MARK	DATE	DESCRIPTIONS	BY	CH'D	CCO#
		REVISIONS			
2	01/31/07	WEST DEVIATION SADDLE GEOMETRY	AS	JD	15
1	07/21/06	W2 CAP BEAM ISD	JD	NV	23

SAN FRANCISCO OAKLAND BAY BRIDGE
EAST SPAN SEISMIC SAFETY PROJECT
SELF-ANCHORED SUSPENSION BRIDGE
(SUPERSTRUCTURE & TOWER)

W2 CAP BEAM DIMENSION DETAILS NO.6

SAN FRANCISCO OAKLAND BAY BRIDGE
EAST SPAN SEISMIC SAFETY PROJECT
SELF-ANCHORED SUSPENSION BRIDGE
(SUPERSTRUCTURE & TOWER)
W2 CAP BEAM DIMENSION DETAILS NO. 7

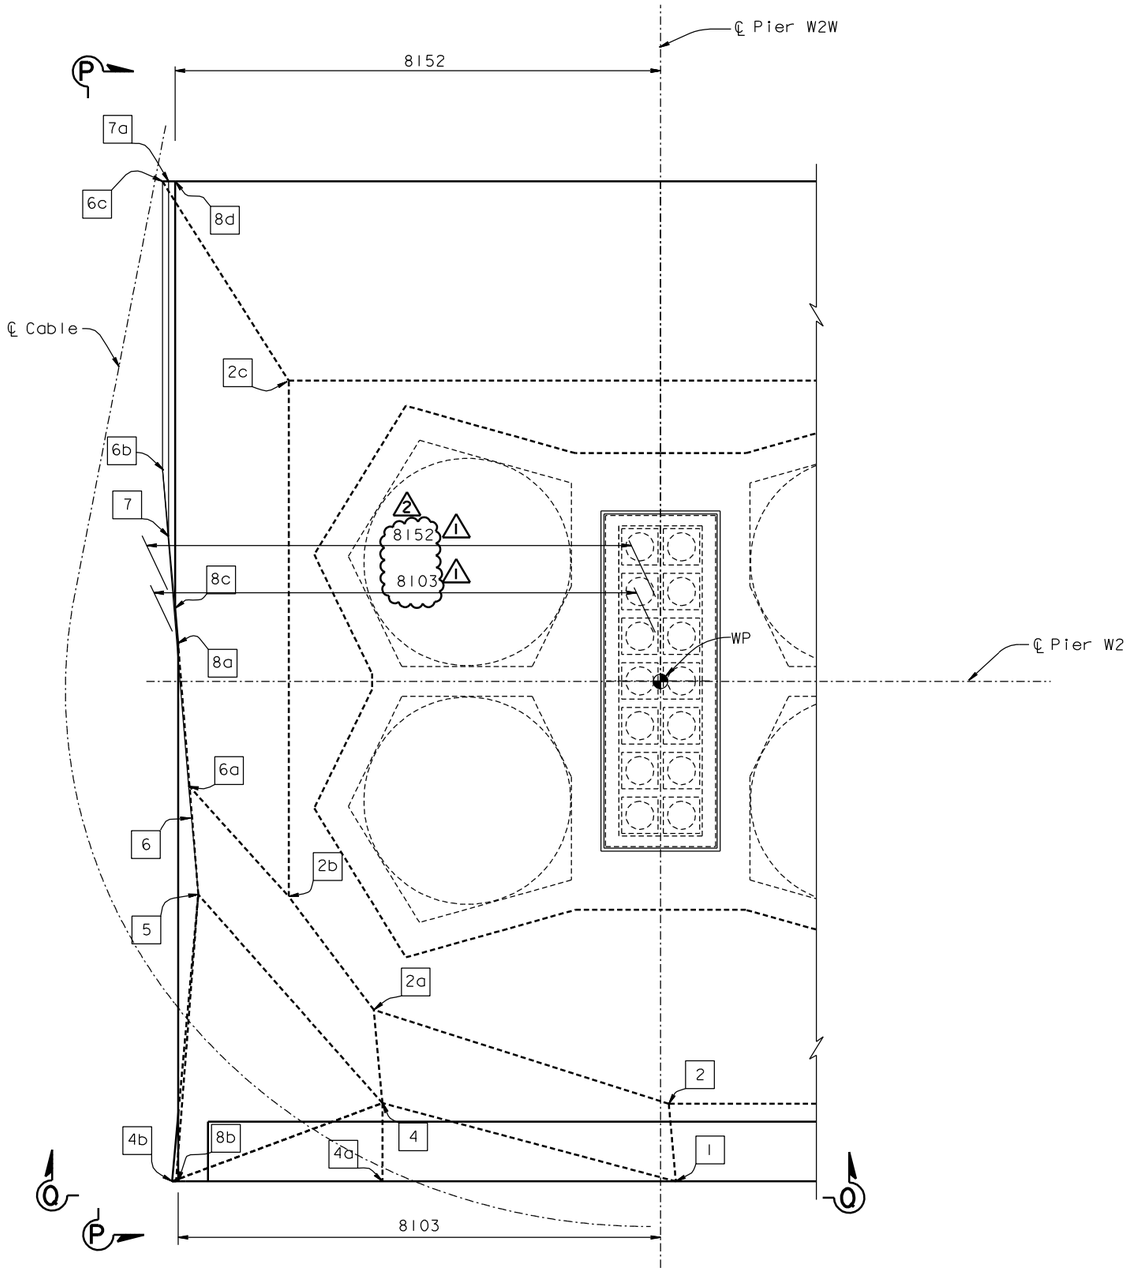
MARK	DATE	DESCRIPTIONS	BY	CH'D	CCO#
		REVISIONS			
2	01/31/07	WEST DEVIATION SADDLE GEOMETRY	NV	JD	15
1	07/21/06	W2 CAP BEAM ISD	JD	NV	23

W2 CAP BEAM DIMENSION DETAILS NO. 8

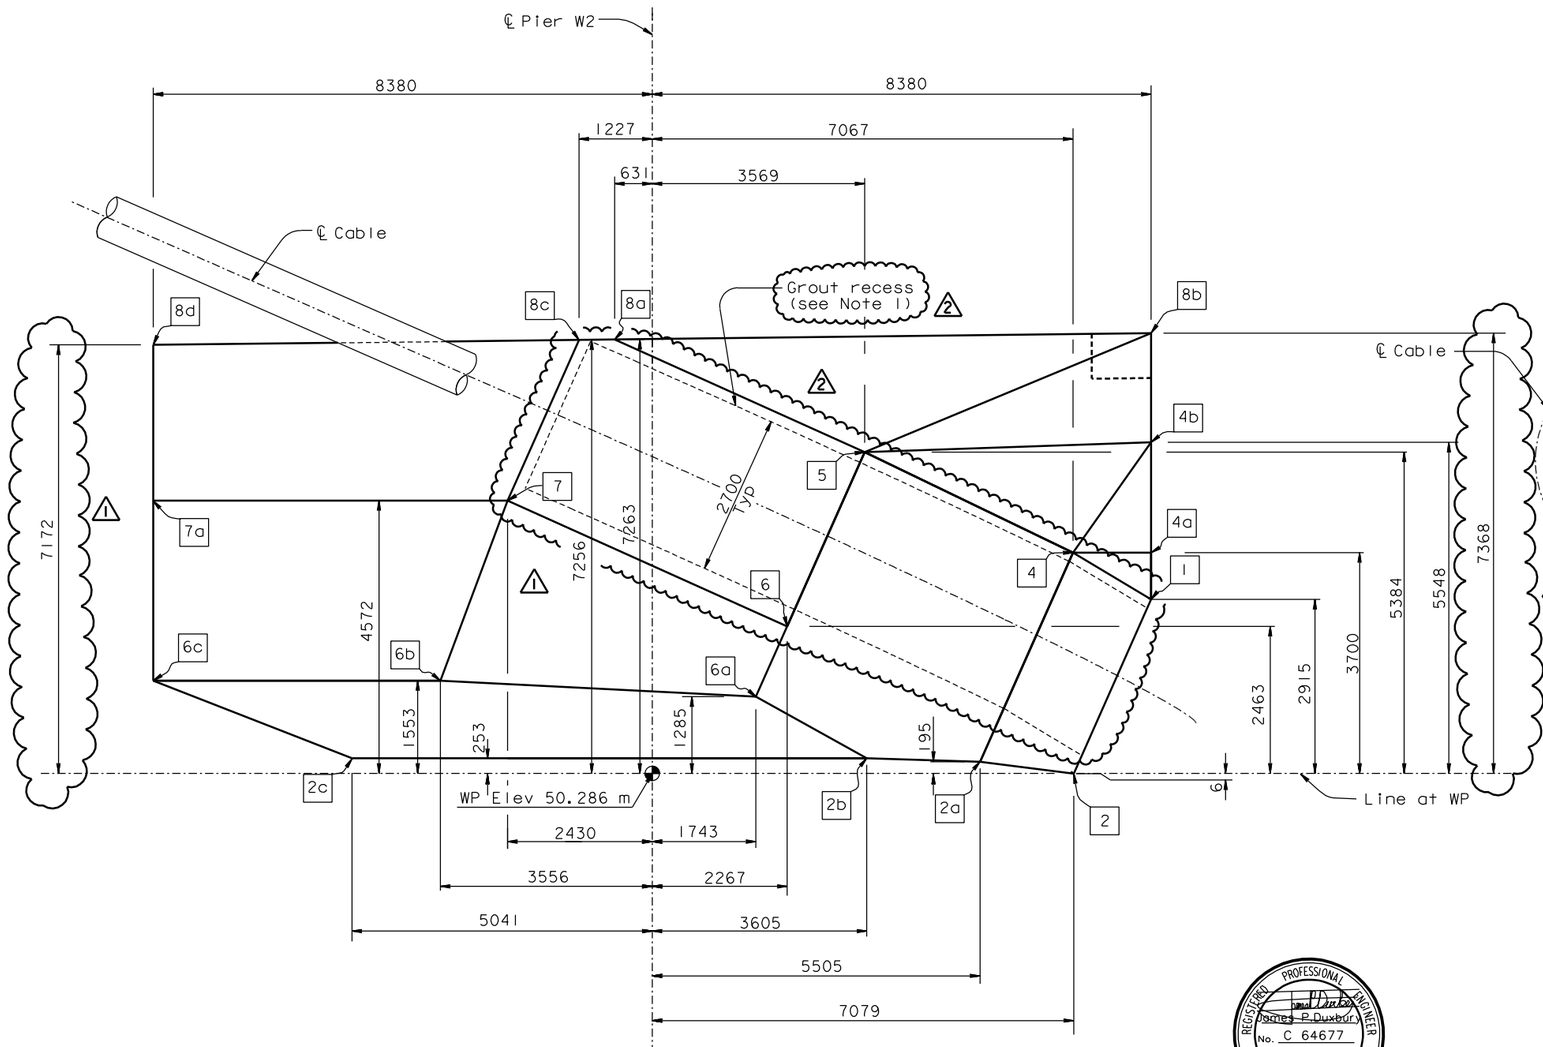
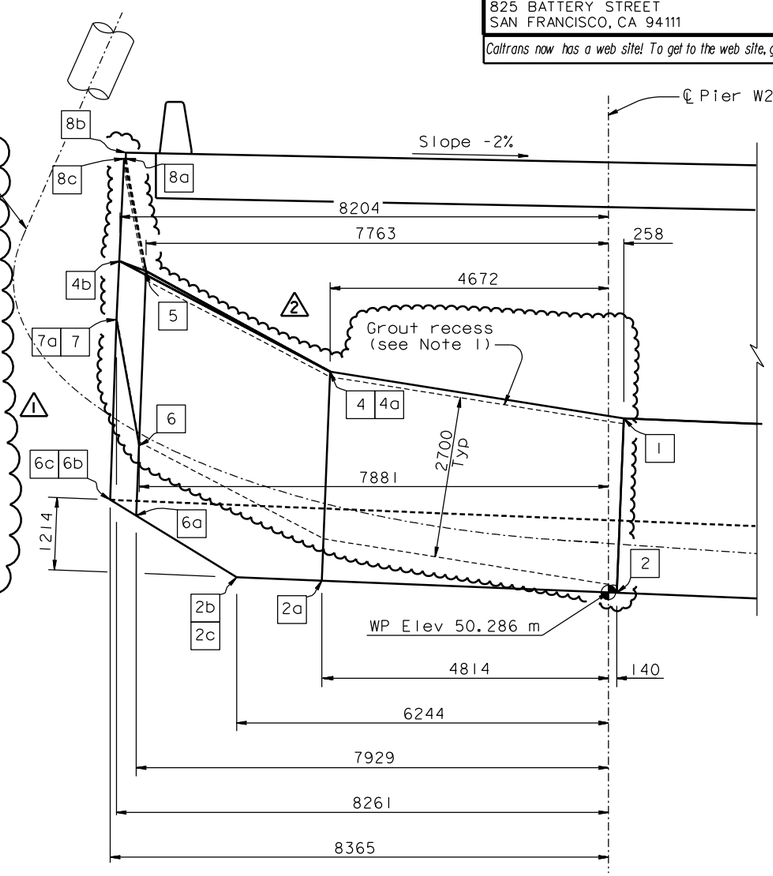
MARK	DATE	DESCRIPTIONS	BY	CH'D	CCO#
		REVISIONS			
2	01/31/07	WEST DEVIATION SADDLE GEOMETRY	JD	NV	15
1	07/21/06	W2 CAP BEAM ISD	JD	NV	23

2. West deviation saddle grout recess (depth = 50 mm) shall be parallel to concrete faces of cap beam. For details see "West Deviation Saddle Details No.1" and "West Deviation Saddle Details No.2" sheets.

W2 CAP BEAM POST-TENSIONING DETAILS NO. 10

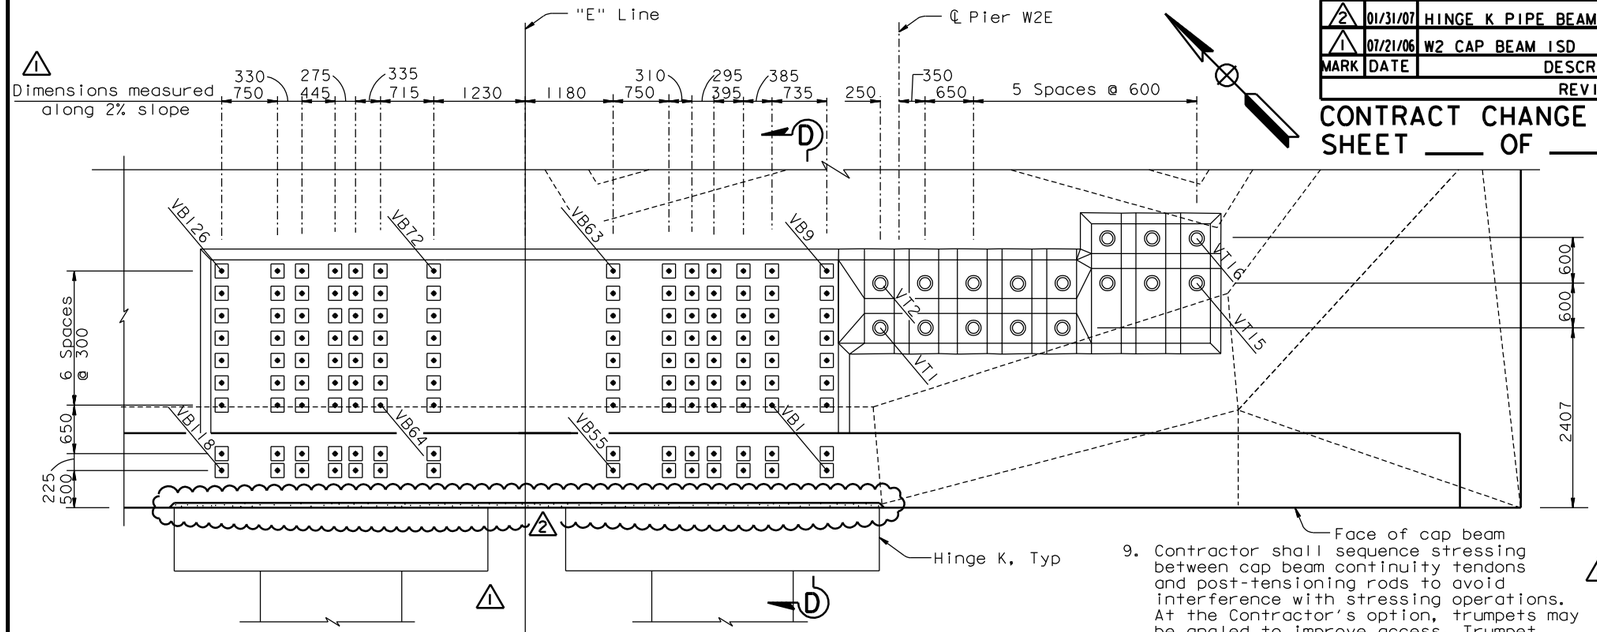
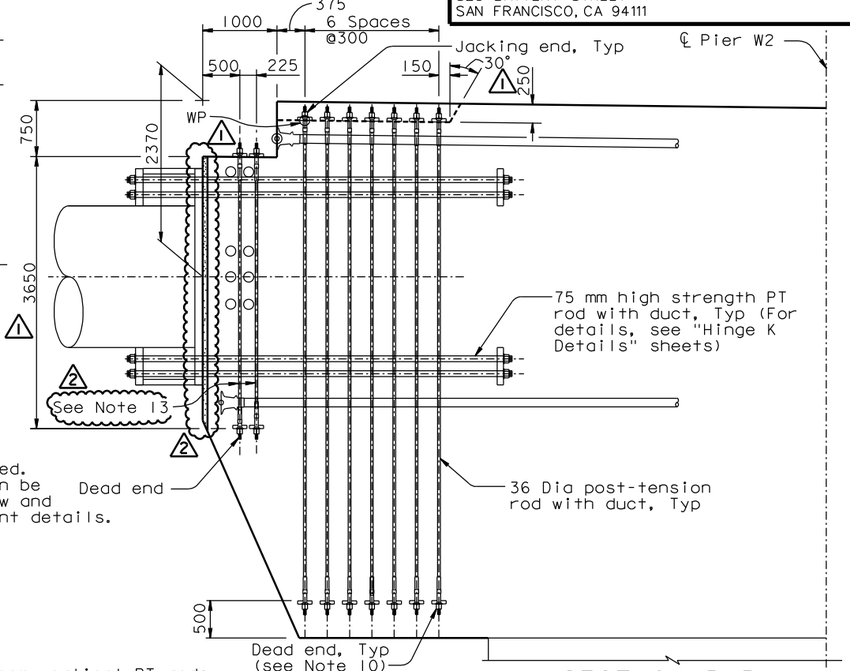
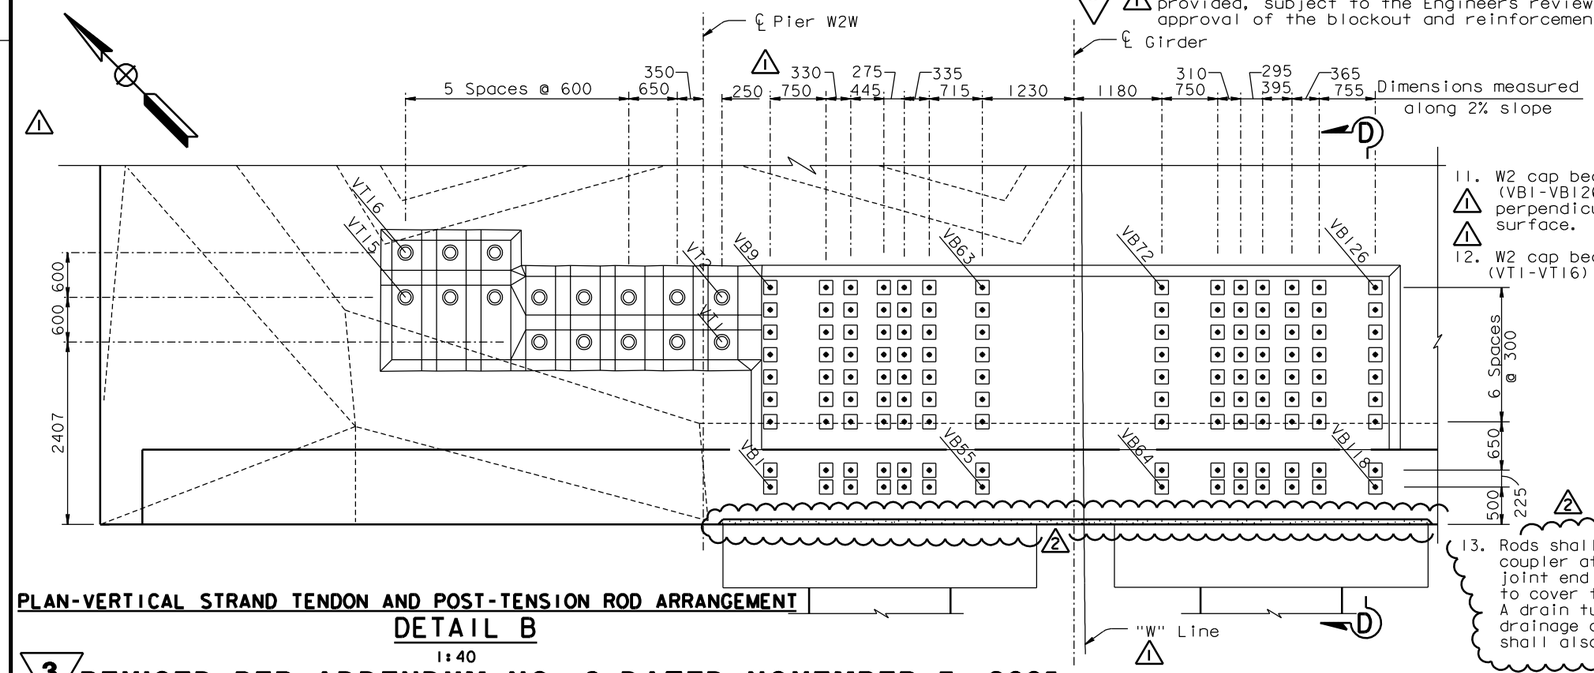
MARK	DATE	REVISIONS	BY	CH'D	CCO#
2	01/31/07	HINGE K PIPE BEAM BLOCKOUTS	JD	NV	15
1	07/21/06	W2 CAP BEAM ISD	JD	NV	23

3 REVISED PER ADDENDUM NO. 3 DATED NOVEMBER 7, 2005

3 / 1 10. Blockouts at the dead end are not required. At the Contractor's option, blockouts can be provided, subject to the Engineers review and approval of the blockout and reinforcement details.

W2 CAP BEAM REINFORCEMENT DETAILS NO. 49

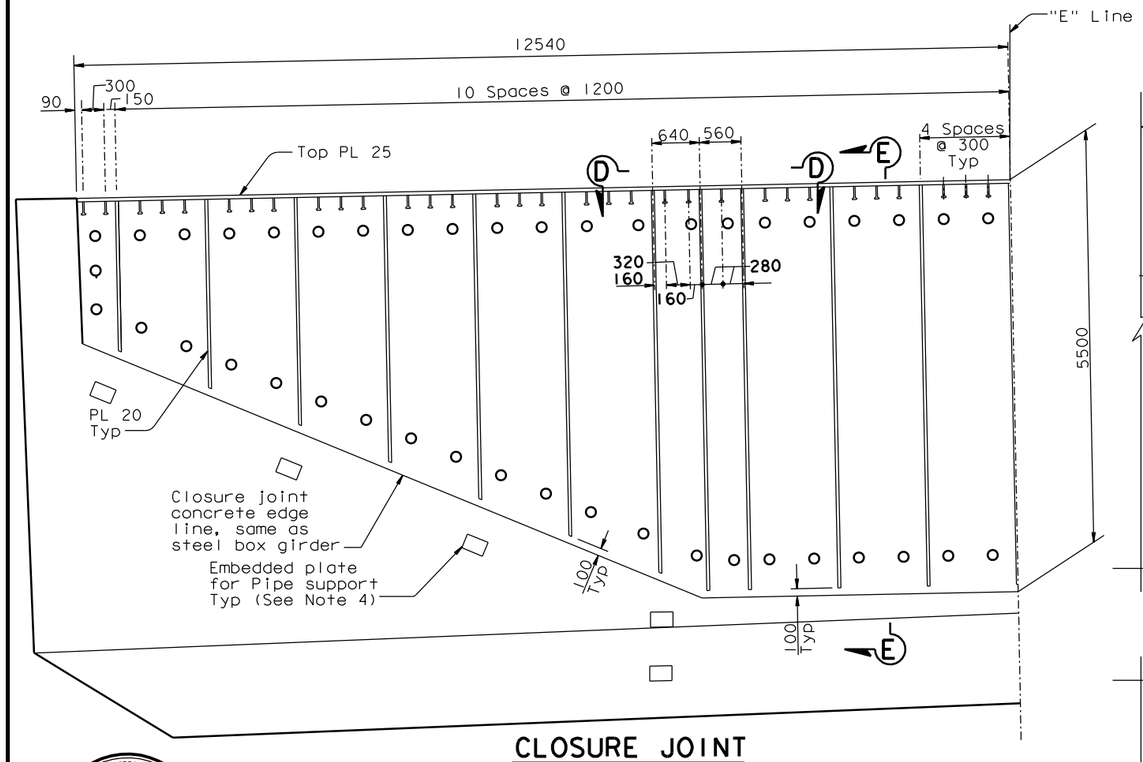
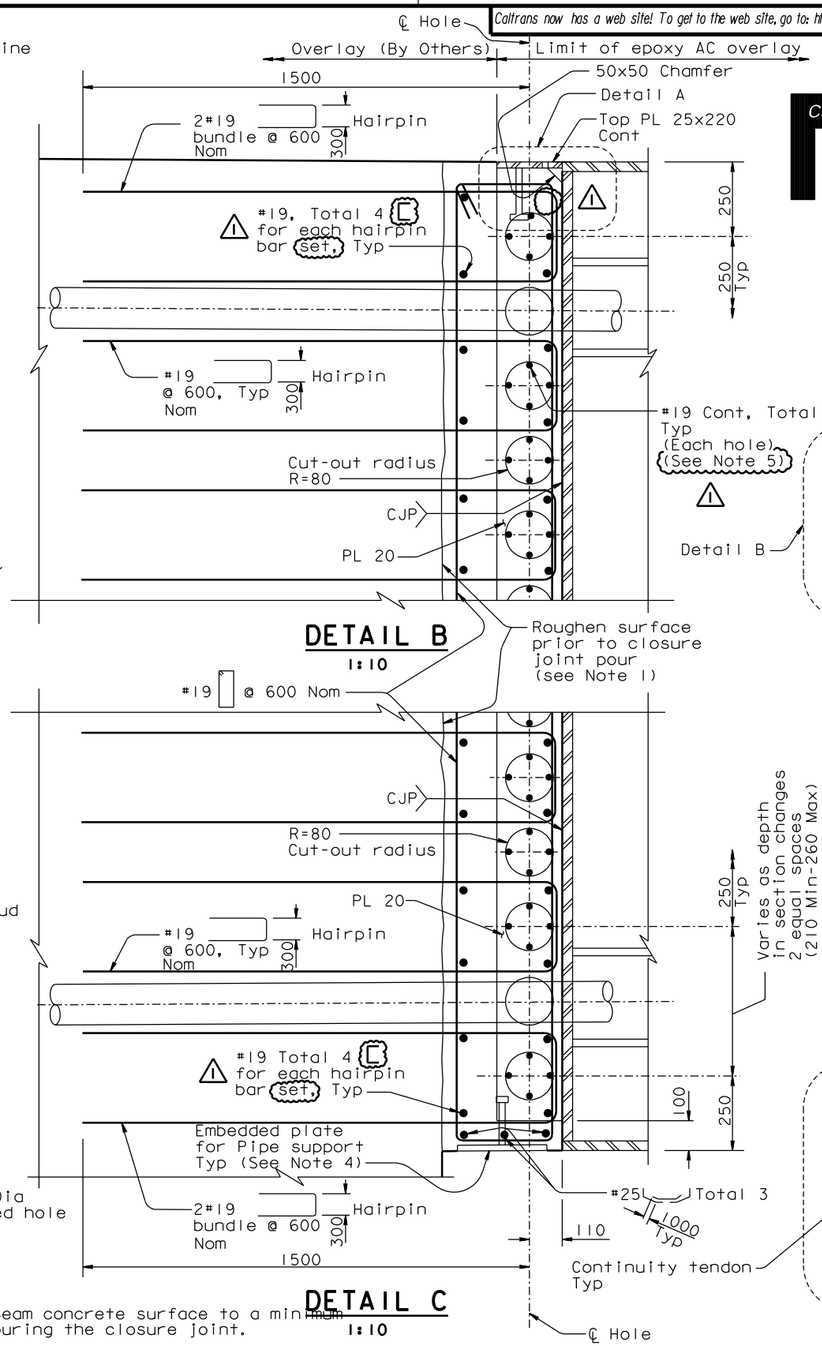
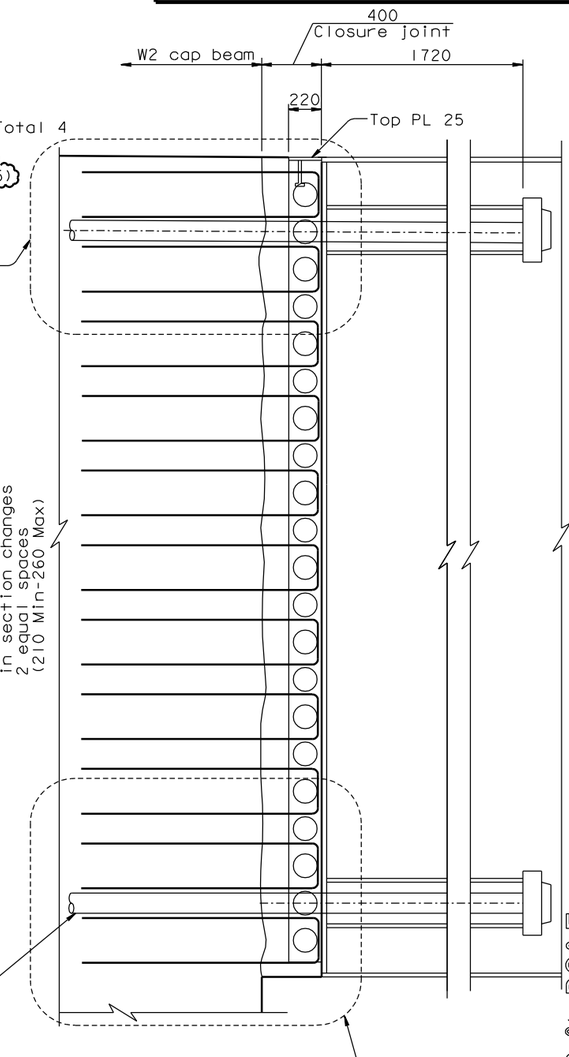
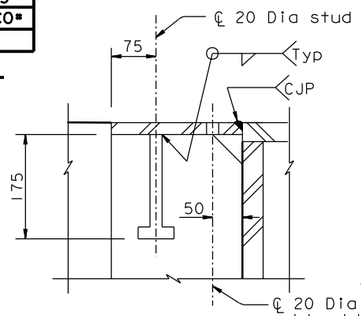
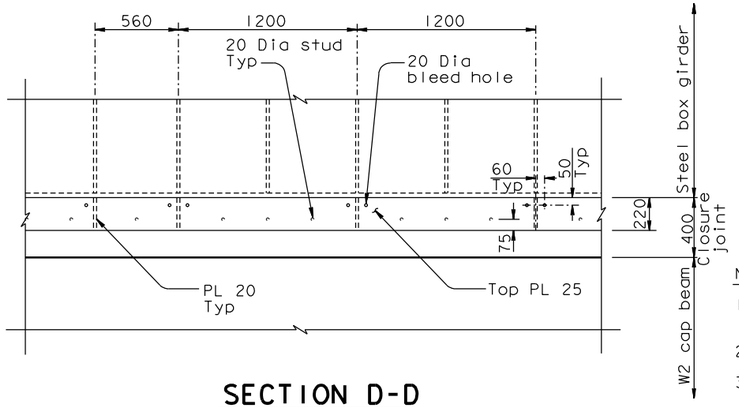
MARK	DATE	DESCRIPTIONS	BY	CH'D	CCO#
		REVISIONS			
1	01/31/07	WEST DEVIATION SADDLE GEOMETRY	JD	AS	15
0	07/21/06	GENERAL REVISIONS	JD	AS	23
